Sydney Metro West - Concept and Stage 1 Modification 2

Modification to relocate and extend the Rosehill dive structure and realignment of Kay Street and Unwin Street.
State Significant Infrastructure Modification Assessment
(SSI 10038 MOD 2)

June 2022

Published by the NSW Department of Planning and Environment

Figure 3 | Proposed modification to the Rosehill dive structure (Source: Sydney Metro)

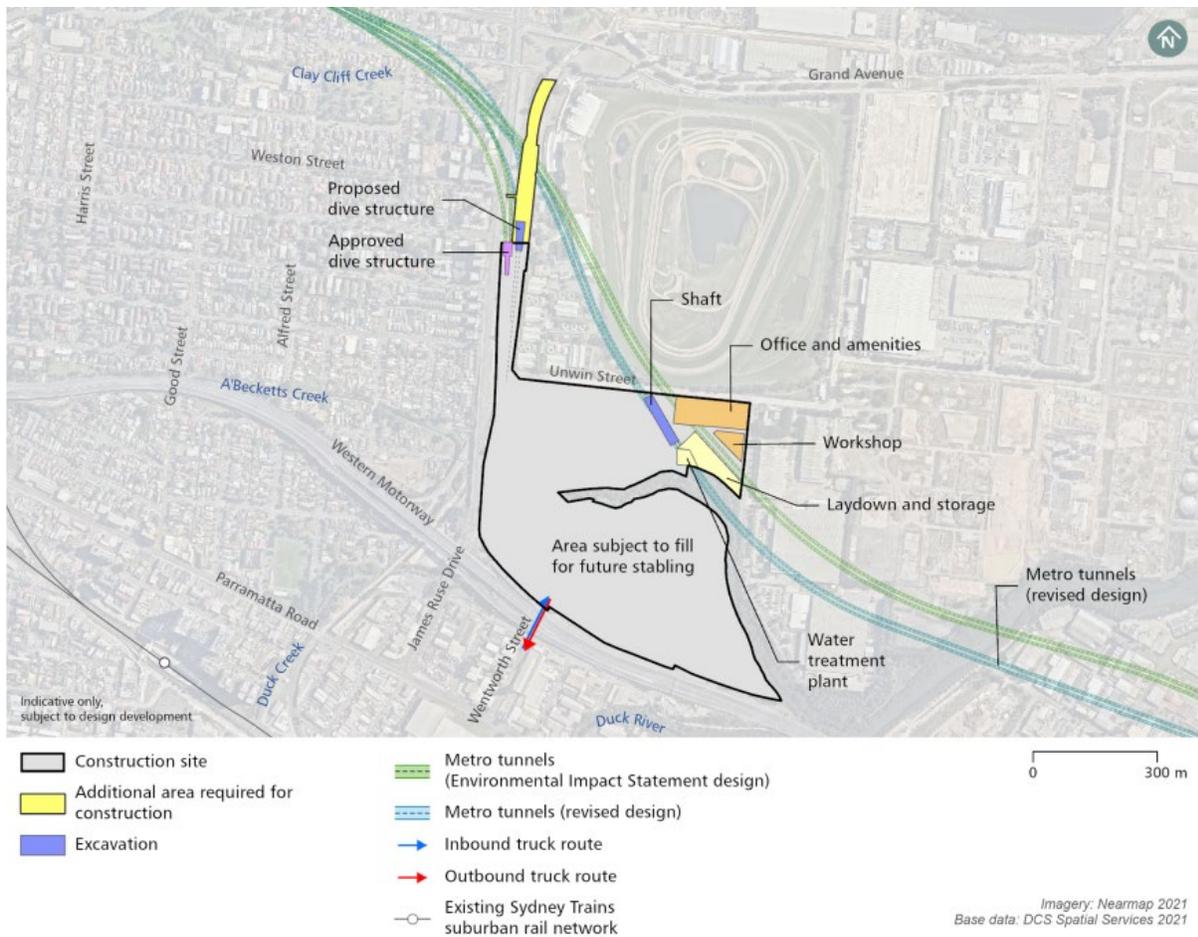
- relocation of the Rosehill dive structure to the east of the approved location and extension of the Rosehill dive structure further north within the former T6 Carlingford line (**Figure 3**)
- additional construction area, previously identified in the Environmental Impact Statement (EIS) as required for Stage 3, to allow for:
 - enabling works as outlined in the EIS
 - removal of the Rosehill Railway Station Footbridge, listed in the RailCorp Heritage and Conservation Register under Section 170 of the Heritage Act 1977 (NSW), which is of local heritage significance and provision for an alternative crossing of the former T6 Carlingford Line prior to removal of the footbridge
 - removal of platforms and station furniture at the former Rosehill Railway Station
- minor realignment of the tunnel portal connecting the mainline tunnels to the revised Rosehill dive structure location.

The approved location for the Rosehill dive structure would require diversion of a major Sydney Water sewer. This would involve intensive construction adjacent to sensitive receivers in an area at risk from flooding and could disrupt service to about 1.5 million people in western Sydney.

The proposed revised location would avoid the need for the sewer diversion and associated community impacts. Remaining within the former rail corridor would also avoid impacts to private property and public roads to the west and commercial property to the east by remaining within the former T6 Carlingford Line rail corridor. Relocation of the dive directly to the north or south of the approved location would also necessitate the sewer relocation and would constrain other construction activities on site.

The Department considers that the proposed modification should be approved subject to conditions. The relocation of the Rosehill dive structure will avoid the need to divert the Sydney Water sewer reducing potential impacts on nearby residents and businesses, and the modified Kay and Unwin St alignment would reduce the need to disturb potentially contaminated soils at the Clyde stabling and maintenance facility.

Figure 4 | Proposed modification to Kay Street and Unwin Street in green (Source: Sydney Metro)

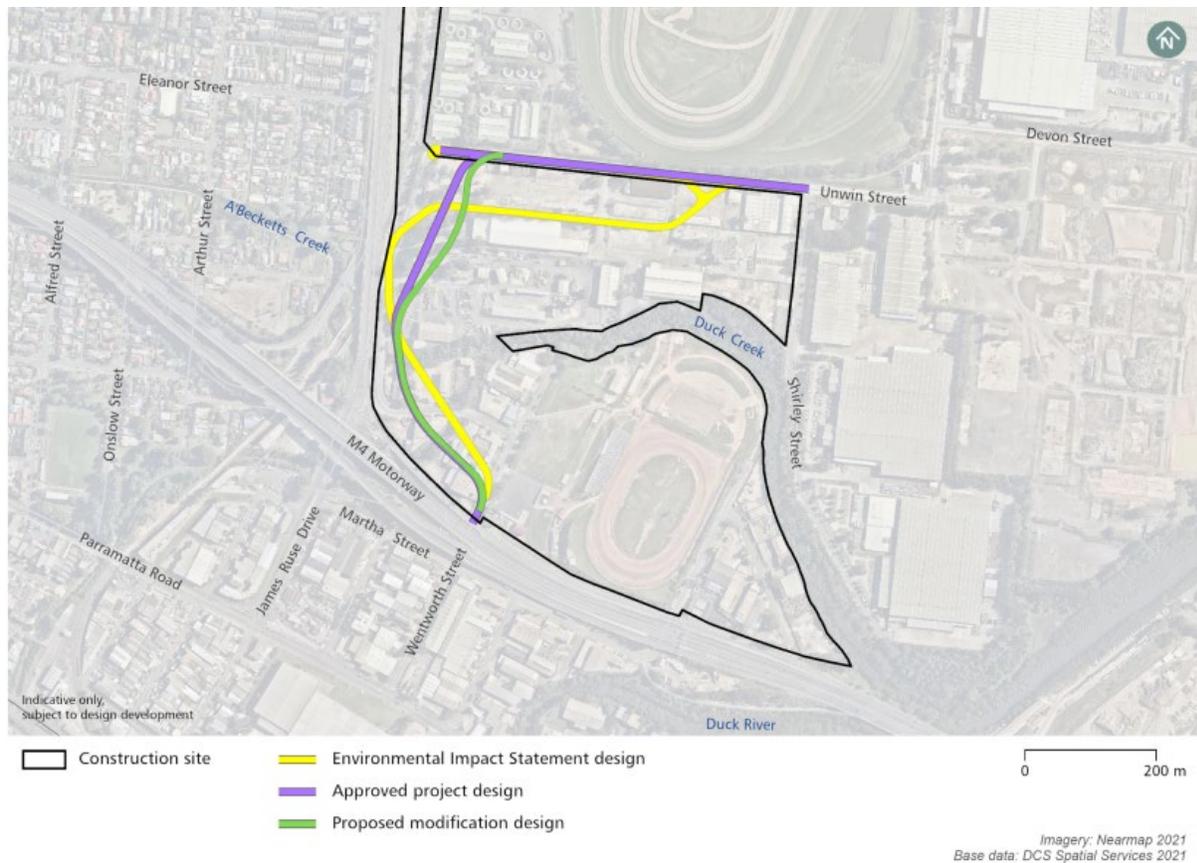
- a road bridge in place of an underpass to cross the future metro rail tracks (**Figure 4**)
- elevation of the Kay Street and Unwin Street realignment for about 250 metres
- minor realignment of the Kay Street and Unwin Street route
- a shared path to accommodate pedestrians and cyclists on one side.

The Department's Planning and Land Use Strategy Division raised concerns that the modification report did not demonstrate that future connections to the M4 as shown in the *Draft Camellia-Rosehill Place Strategy* (DPIE 2021) were not sterilised by the proposed Kay and Unwin streets realignment. Further information was sought to show that the proposed modification would not preclude the M4 connection.

The Proponent confirmed, in a letter dated 13 April, that the M4 connection as proposed in the draft strategy, could be delivered with the proposed realignment of Kay and Unwin streets. The Department has recommended a condition requiring the realignment design ensure this outcome, including retention of the road reserve of Unwin Street between Kay Street and the TfNSW Granville Depot for future use a connection to the M4 and provision of further detailed documentation to the Department's Planning & Land Use Strategy Division to inform master planning of the precinct.

The Department is satisfied that, while the proposed M4 connection does not form part of Sydney Metro West, the realignment of Kay and Unwin streets will not preclude its future delivery by others.

Figure 5 | Rosehill Gardens Racecourse (source: ATC website)

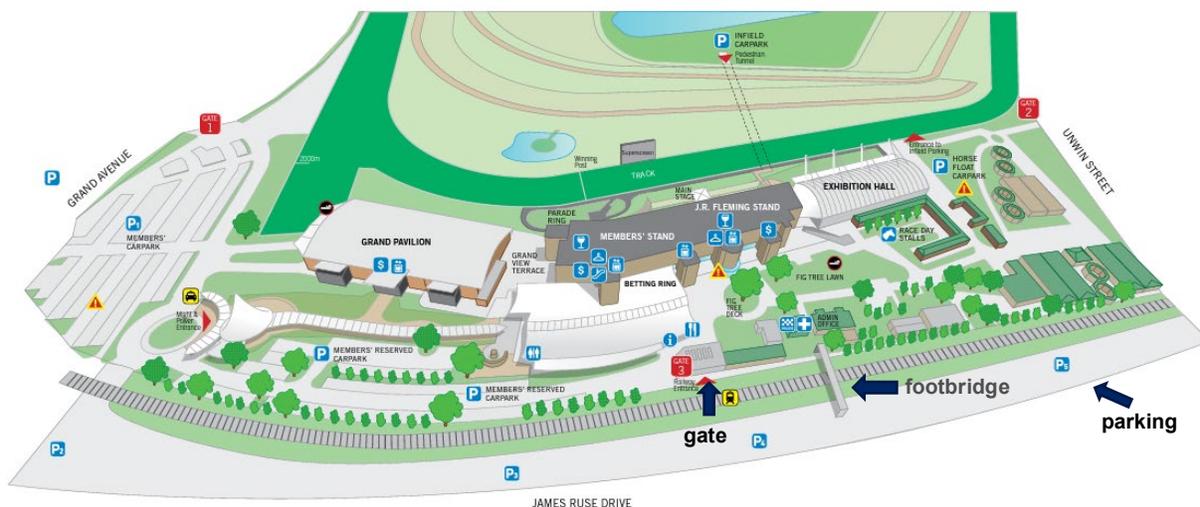
Australian Turf Club (ATC) raised access as an issue in its submission and requested more details regarding access from its P5 carpark to the racecourse, in particular Gate 3.

The Rosehill Railway Station Footbridge (see **Figure 5**) provides direct pedestrian access across the decommissioned rail corridor to Rosehill Gardens Racecourse (Gate 3) and other industrial areas on the eastern side and aligns with the intersection of Weston Street and JRD, however there is no pedestrian crossing in this location.

While the Department acknowledges the proponent's commitment to consult with the ATC to provide an alternative crossing, the commitment is lacking in performance-based outcomes and detail to consider how the current access is used on a daily basis as well as for public race days and other key hospitality and conference events in developing its replacement. A new condition is therefore recommended which identifies performance outcomes in terms of location, safety and accessibility as well as design in consultation with the ATC, landowners and the relevant road authority. The Modification Report indicates that the temporary access will be made permanent at some future time. The Department has advised the proponent that where this occurs, the design must also consider relevant strategic planning documents and masterplans.

Safe temporary pedestrian access will be provided in consultation with ATC

The Proponent has committed to providing safe access in accordance with Condition D98 and that a new, safe alternative crossing of the former T6 Carlingford Line would be provided if the footbridge is removed, however there was no detail of how or what would be delivered.
